PP/17/07888 132B Fulham Road, LONDON, SW3 6HX

Demolition of dwelling house and erection of a two storey 2-bedroom detached house with subterranean development

I write again for the Kensington Society and in support of our members to object to the application for the demolition and construction of 3 storey house on this small site.

Harm to the living conditions of the adjoining property

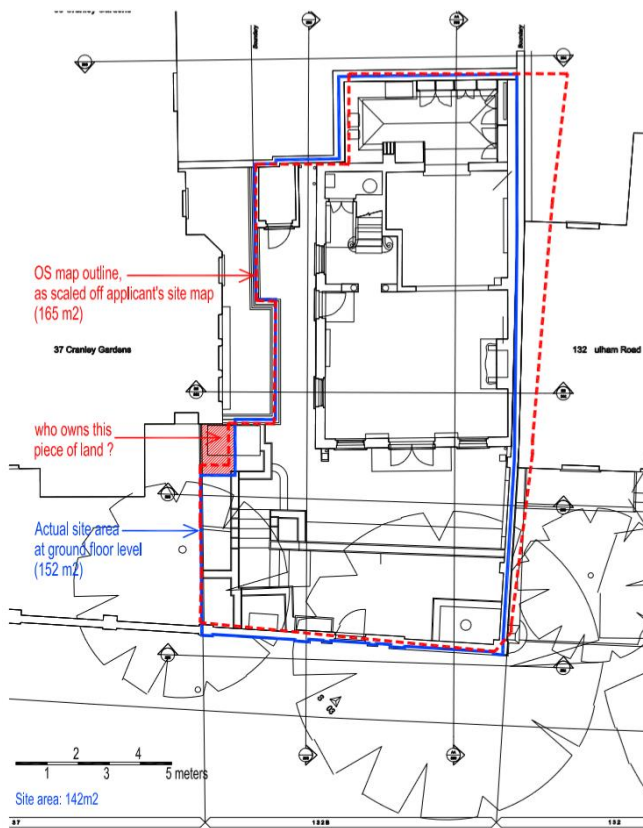
The negative effect of the new structure will harm the good living conditions of the adjoining residents reduce their privacy, increase the overlooking, sense of enclosure, cause light pollution especially No37 Cranley Gardens. The increase in height of the boundary wall between the site and No3's only outdoor space and the lower ground habitable rooms will reduce the daylight and greatly increase the sense of enclosure.

In addition, the extensive, full height and width of the proposed sliding glass windows on the west elevation will further this sense of enclosure and reduce the privacy of No37. This is contrary to CL5 a, b, c, d, and e.

132B Fulham Road - Existing ground floor plan
1:100 @ A3 / RevA on 12.02.2018

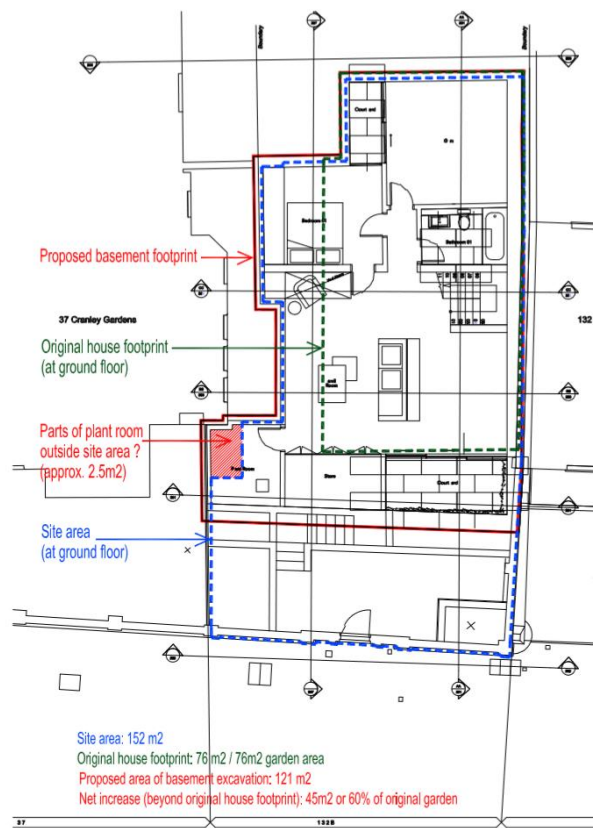
The first map is from the OS map and shows what the application notes as the "site". The next 2 plans are the existing ground floor plan on the left and the proposed basement plan. Notice that the OS map has a corner piece at of the western property line which is not within the site. However, when compared to the next plans the corner is incorporated into the

construction. It even becomes the plant room in the basement. It appears the proposal encroaches into the corner of No37 Crawley Gardens (red area) .
